**NOTICE  
OSHTEMO CHARTER TOWNSHIP  
ZONING BOARD OF APPEALS - REGULAR MEETING**

**Mtg Date:** August 23, 2022

**Property:** 3680 Stadium Park Way, Parcel Number 05-34-155-050

**Request:** Site plan approval to construct a 30,084 SF building addition, a 749 SF building addition, and a 1,023 SF building addition onto the existing 34,989 SF building on-site.

**22-107**  
Sheet Name:  
SITE LAYOUT PLAN

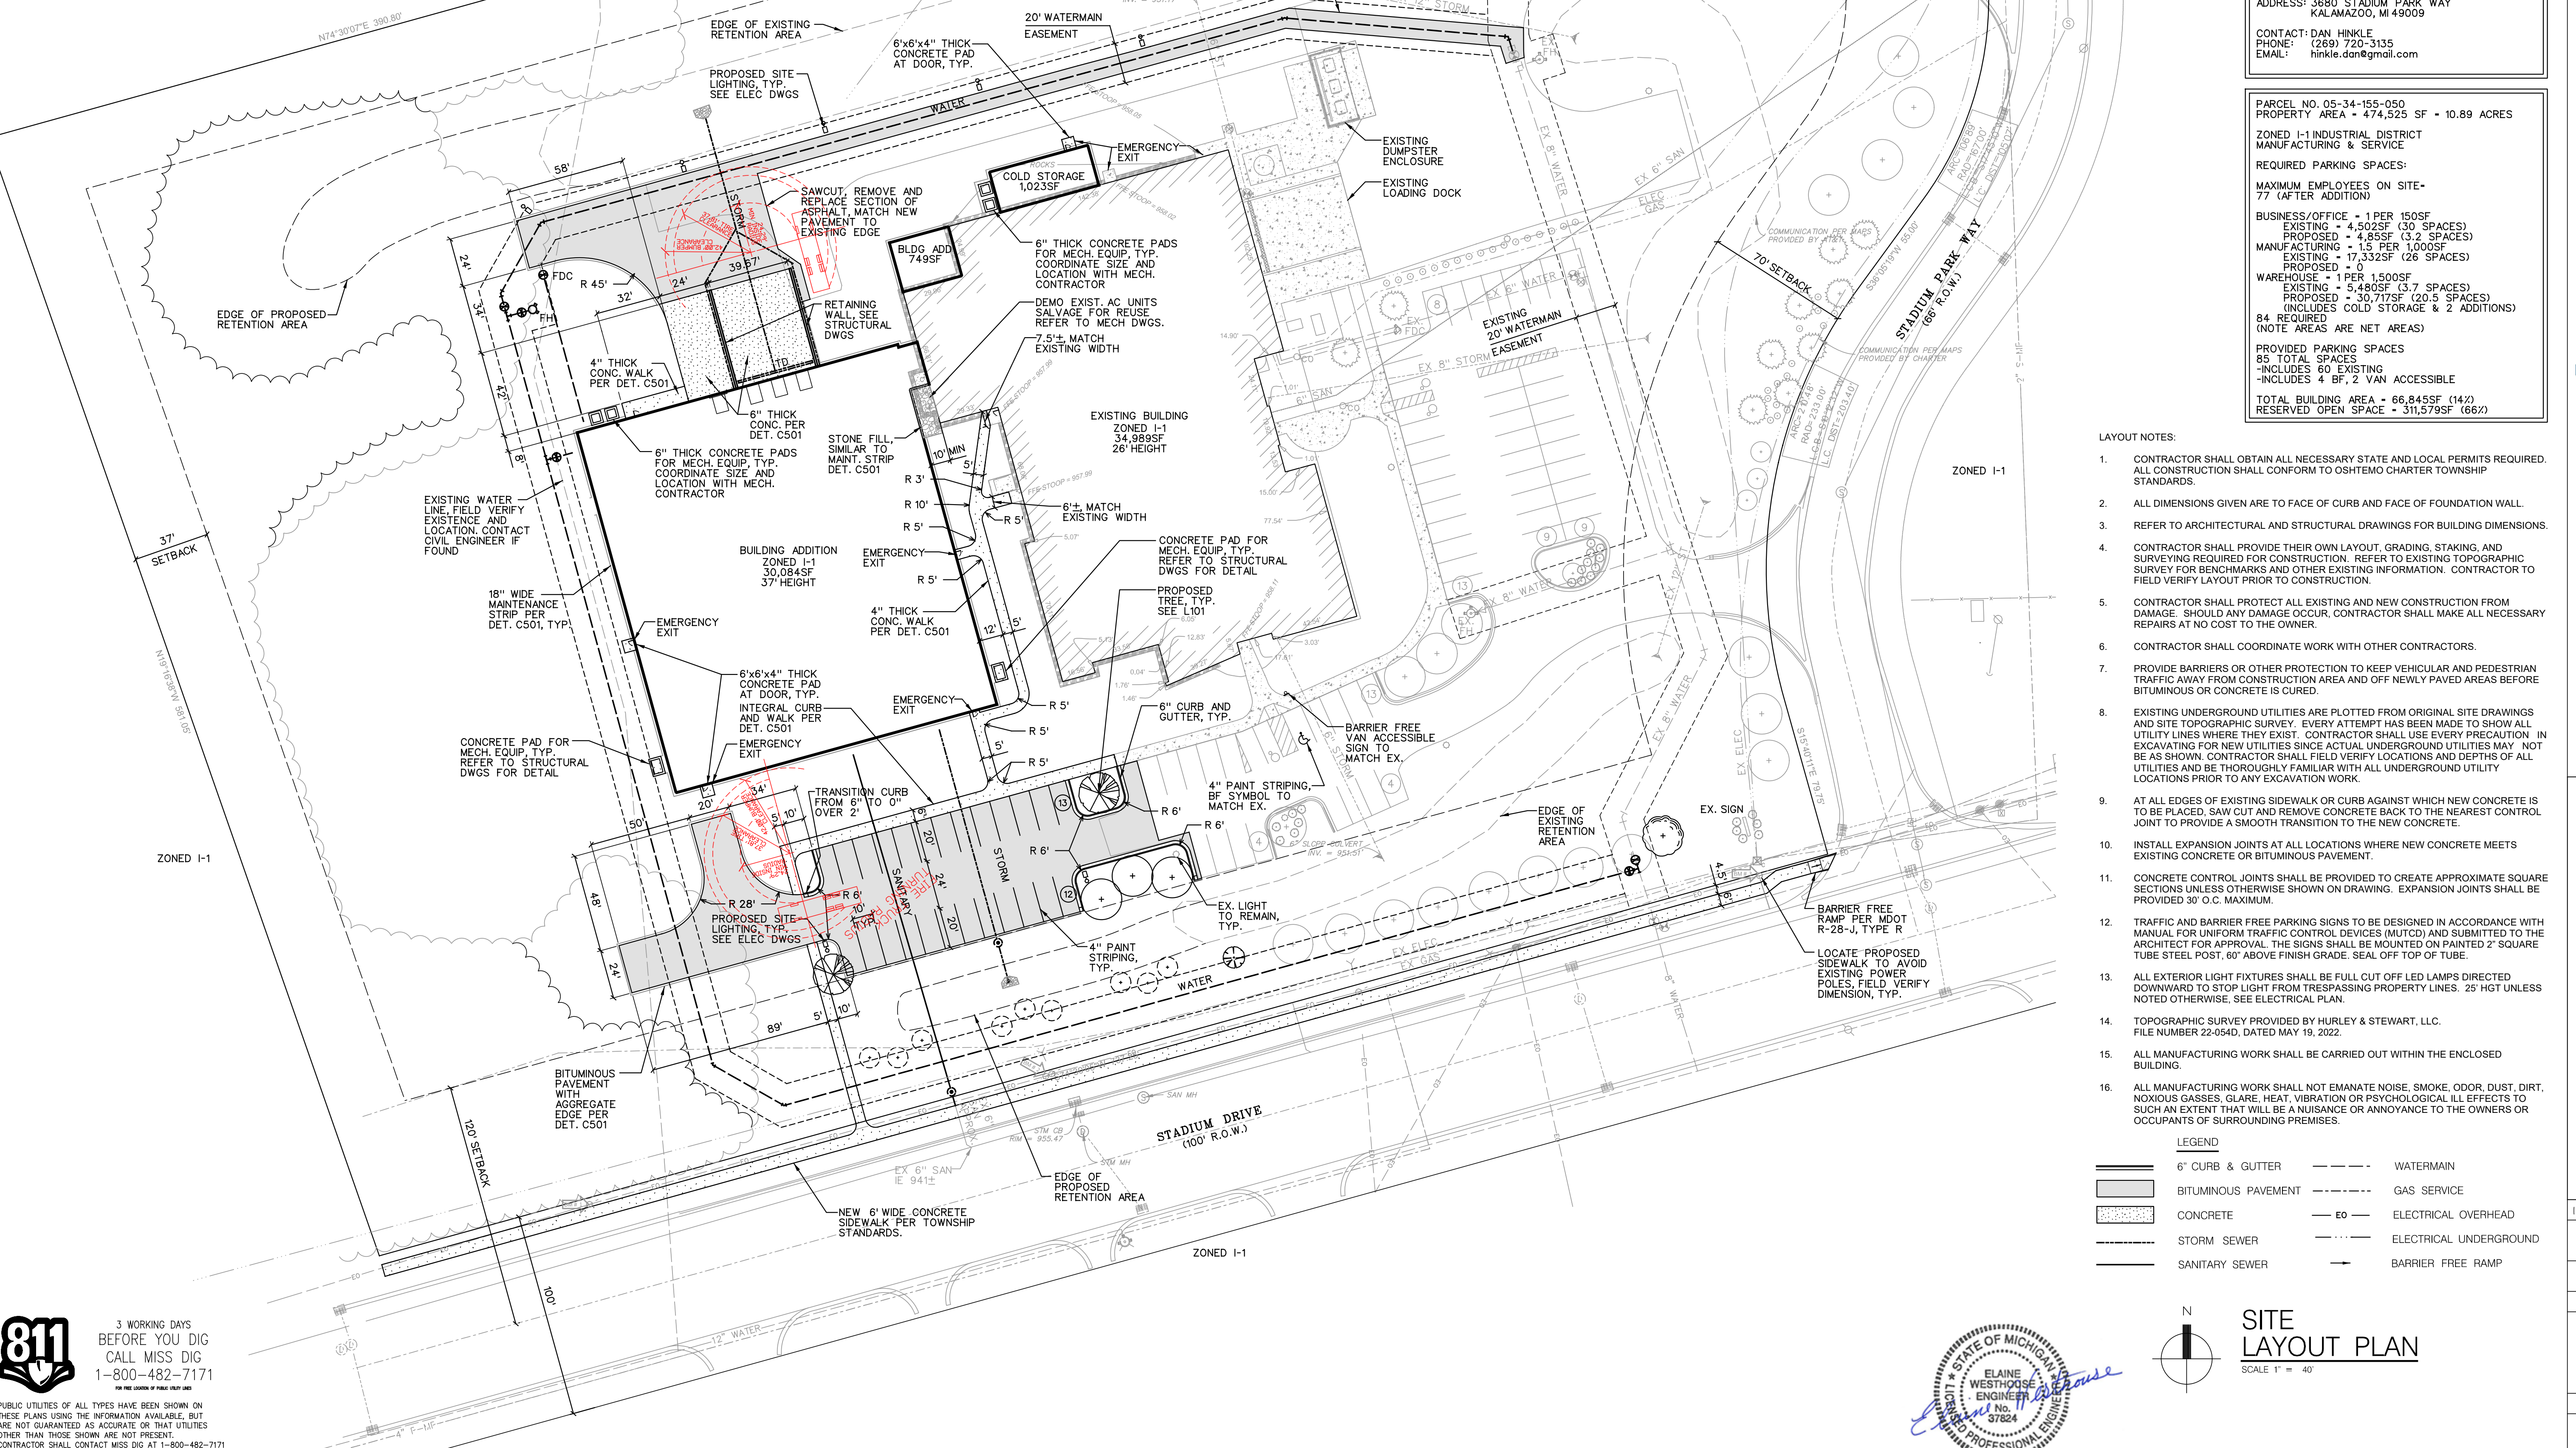
- A. All work must be carried on within an enclosed building.  
**Requirement Satisfied. Please see Note 15 on Sheet C101 of Site Plan.**
- B. Work carried on must not emanate noise, smoke, odor, dust, dirt, noxious gases, glare, heat, vibration or psychological ill effects to such an extent as will be a nuisance or annoyance to owners or occupants of surrounding premises.  
**Requirement Satisfied. Please see Note 16 on Sheet C101 of Site Plan.**

**(A) BUILDING ELEVATION (EAST)**  
 1/16" = 1'-0"

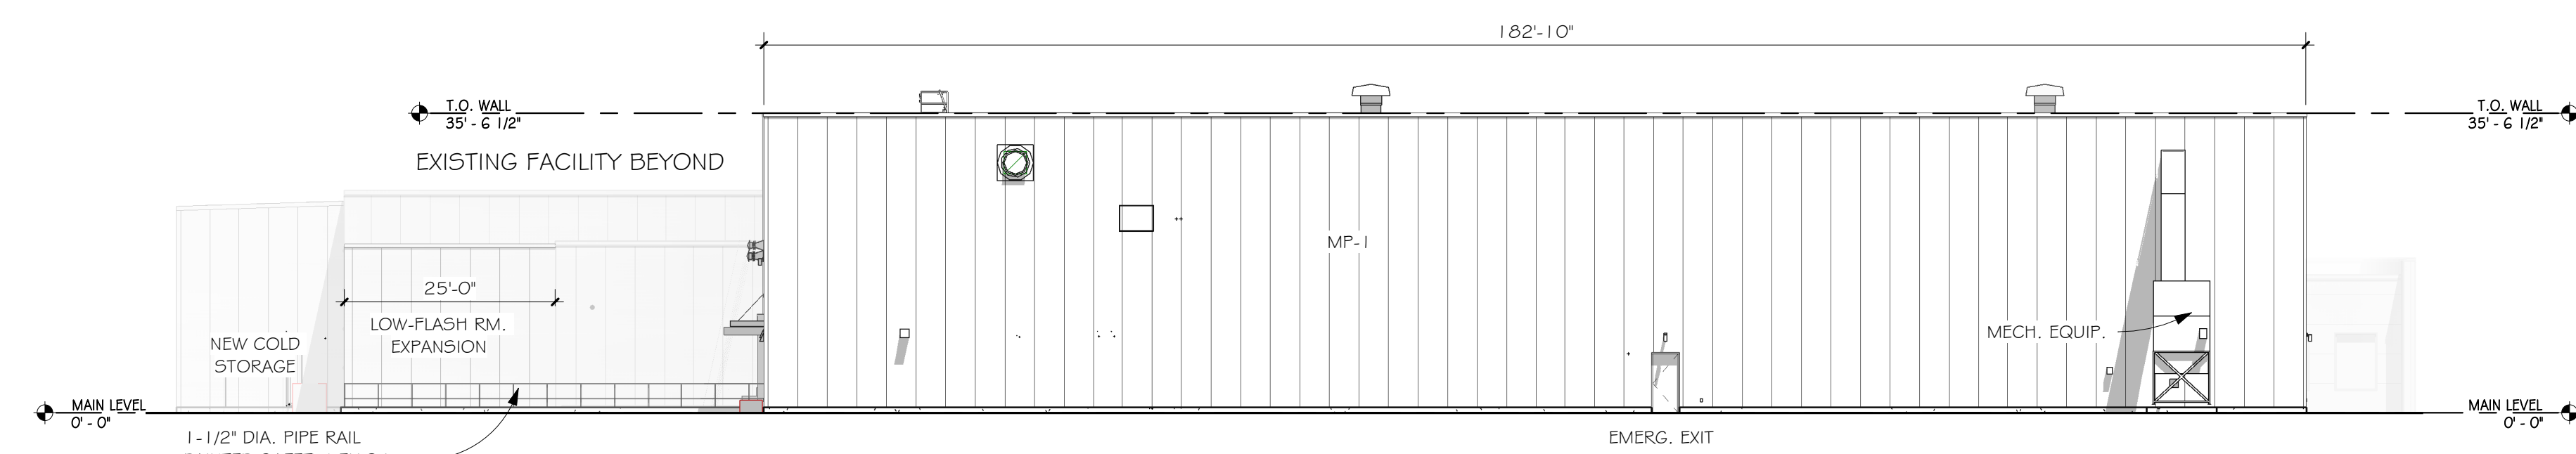
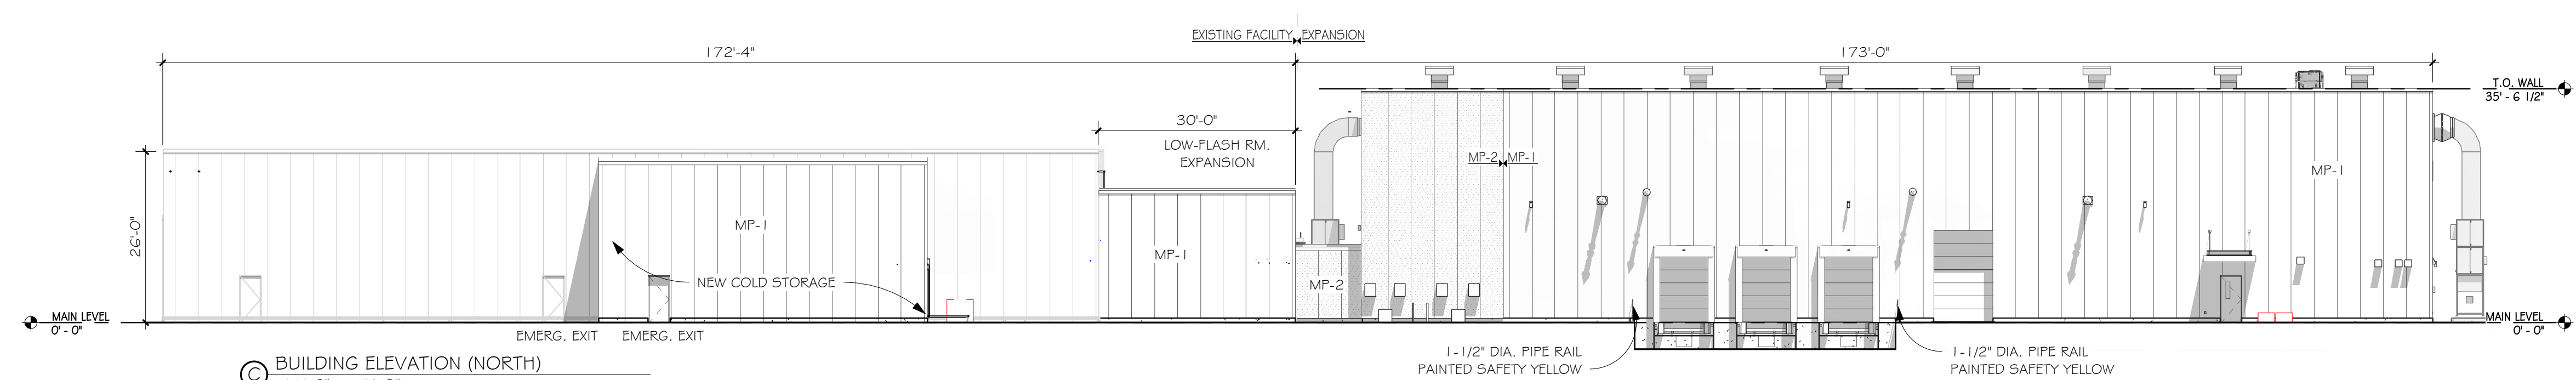
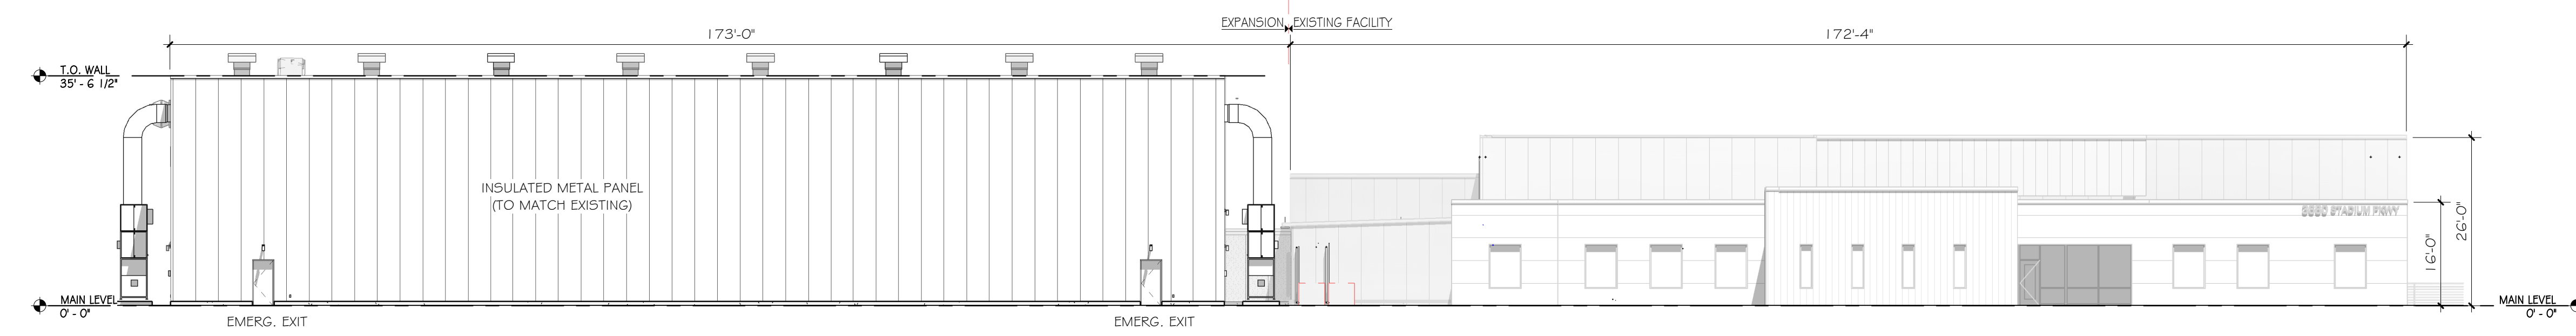
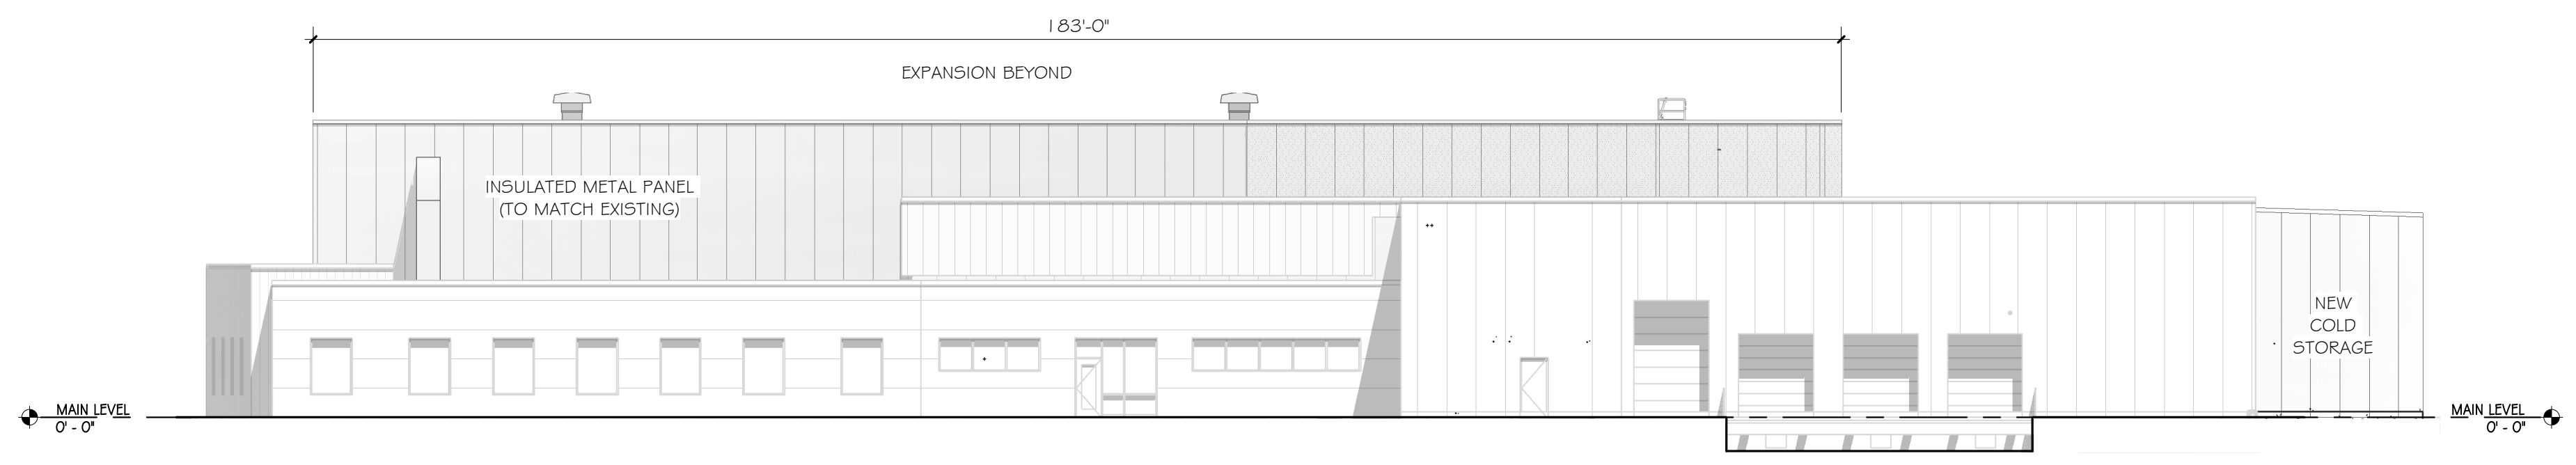
*Building Information:* The 34,989 SF building was originally constructed in 2017 and is approximately 26 Ft tall. The proposed building additions will be located on the north and west ends of the existing building, combining for a total of 31,856 SF in additional square footage. The exterior material proposed for the addition is an insulated metal panel siding that is gray in color. The elevation sheet that was submitted with the site plan shows that the addition will match the existing façade and architectural features of the existing portion of the building. See images of the building’s elevations below.
